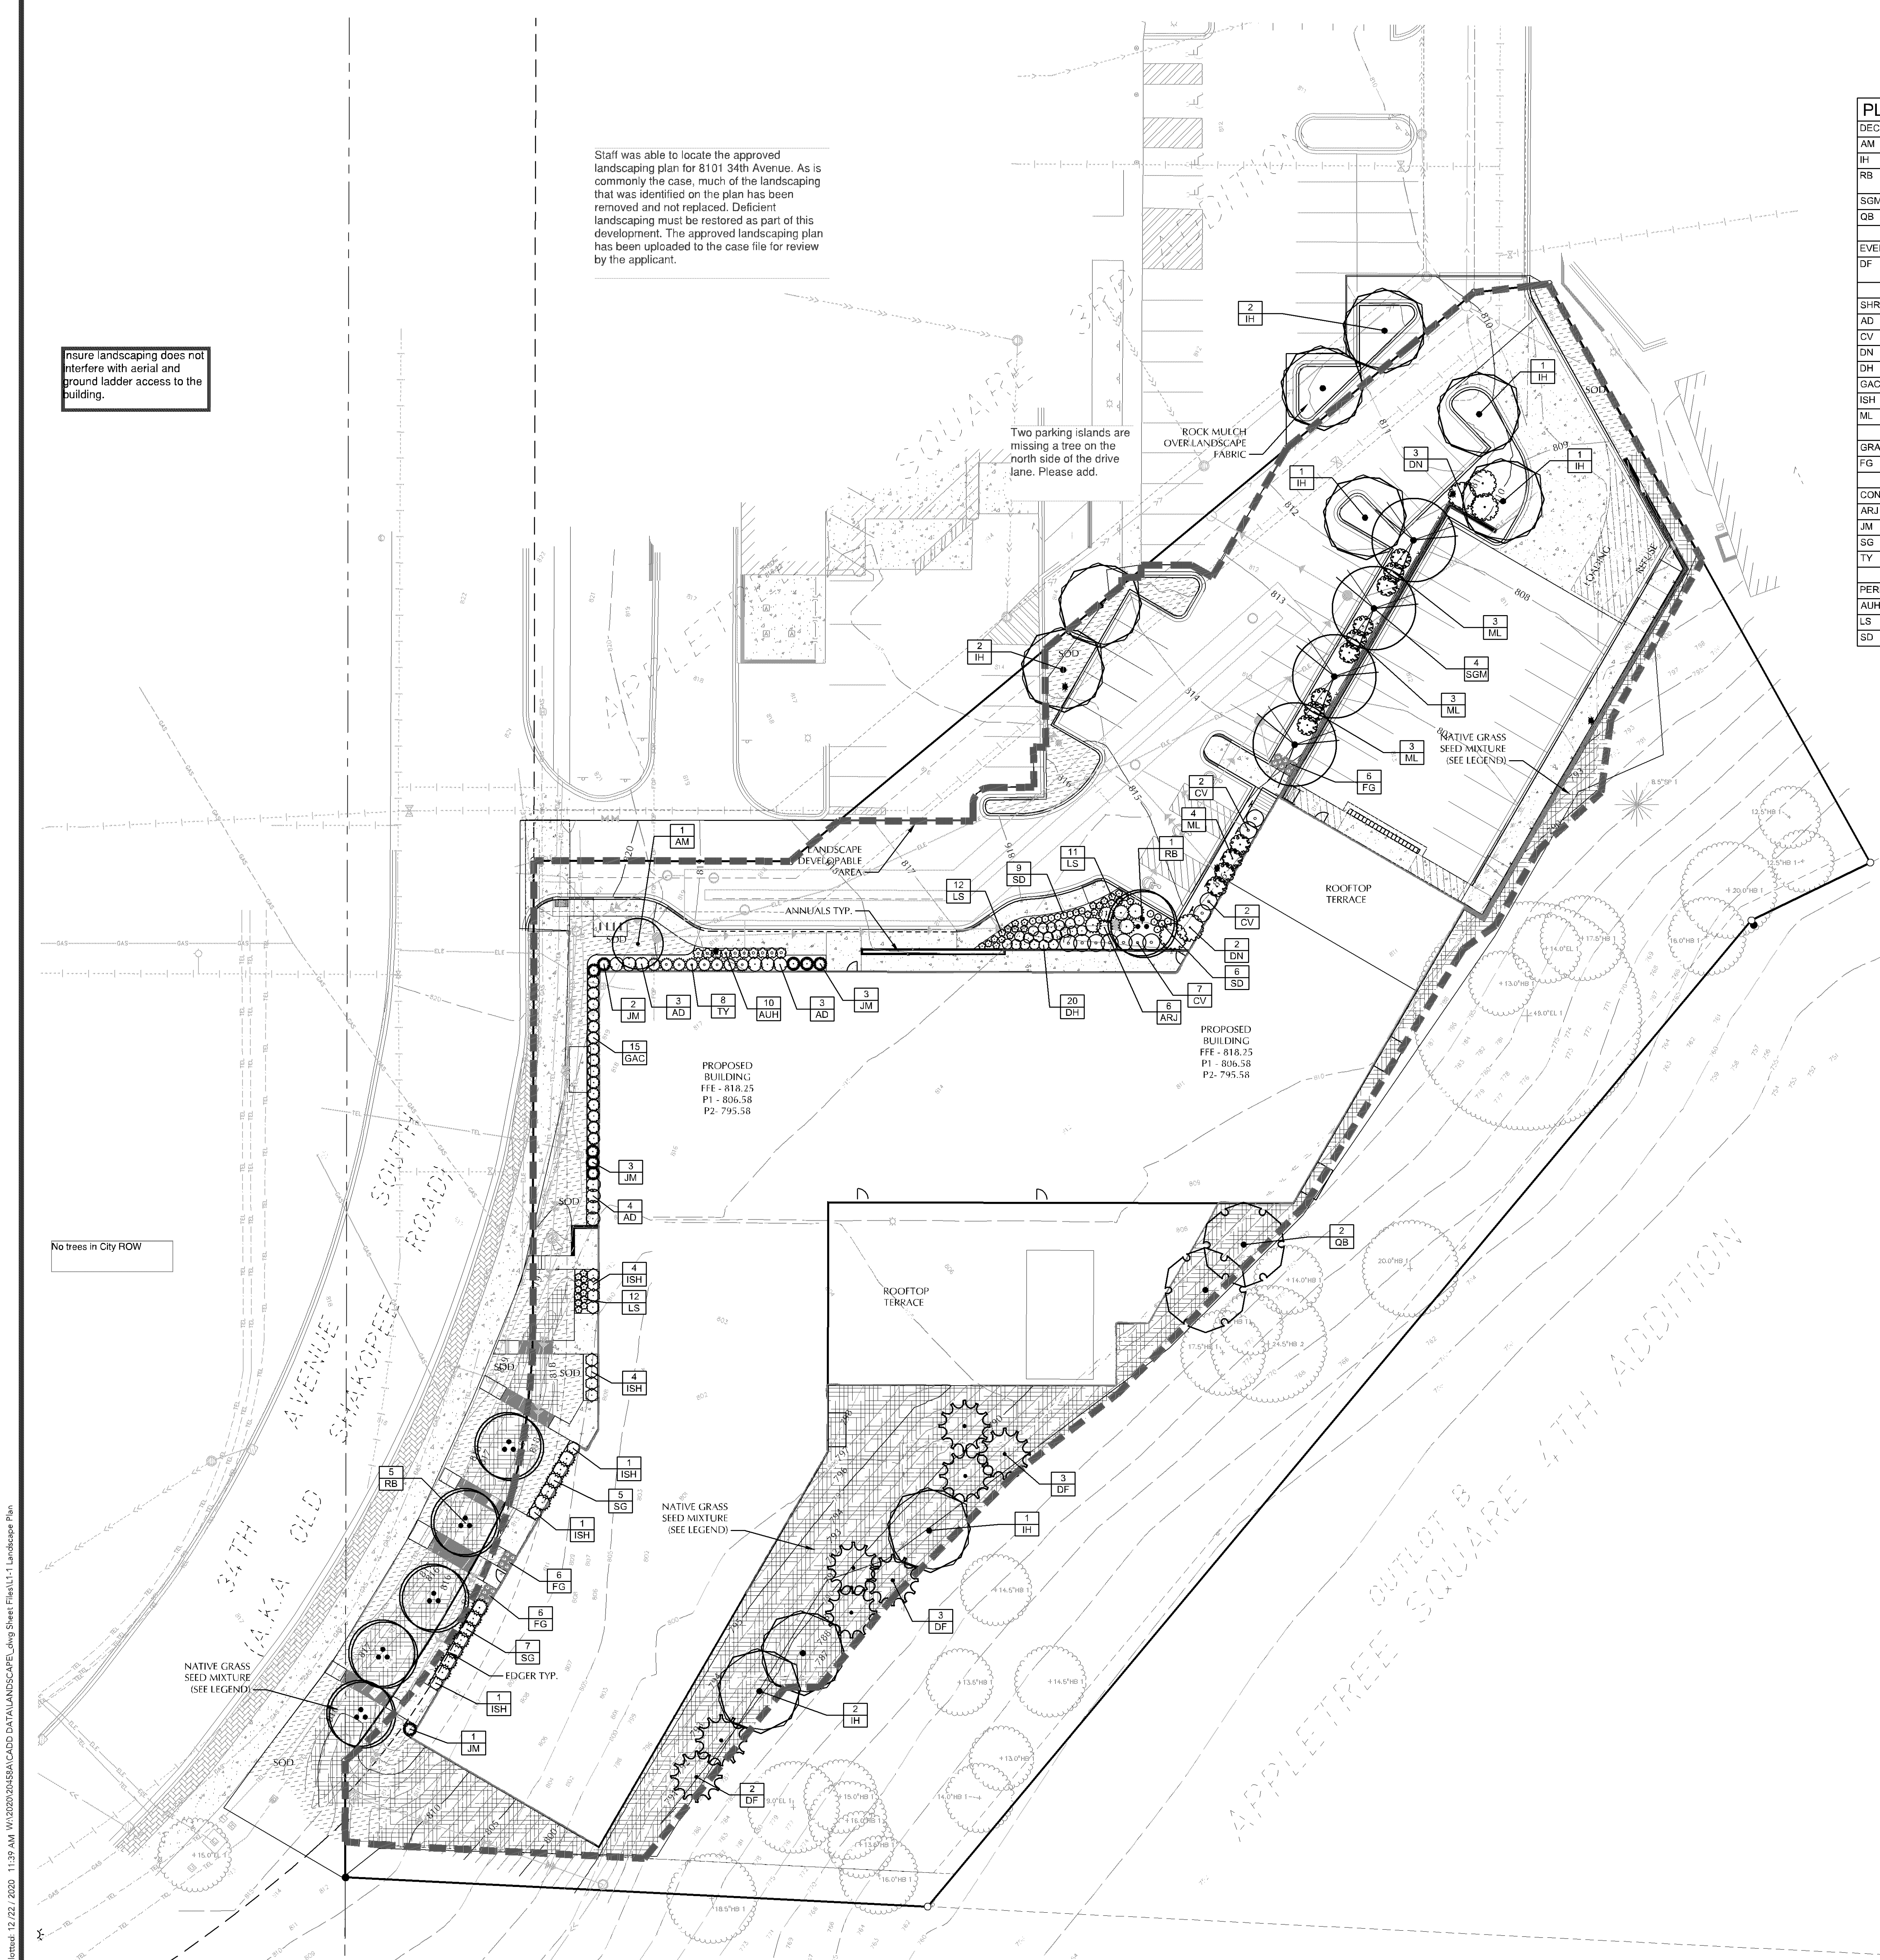
Staff was able to locate the approved landscaping plan for 8101 34th Avenue. As is commonly the case, much of the landscaping that was identified on the plan has been removed and not replaced. Deficient landscaping must be restored as part of this development. The approved landscaping plan has been uploaded to the case file for review by the applicant.

Ensure landscaping does not interfere with aerial and ground ladder access to the building.

Two parking islands are missing a tree on the north side of the drive lane. Please add.
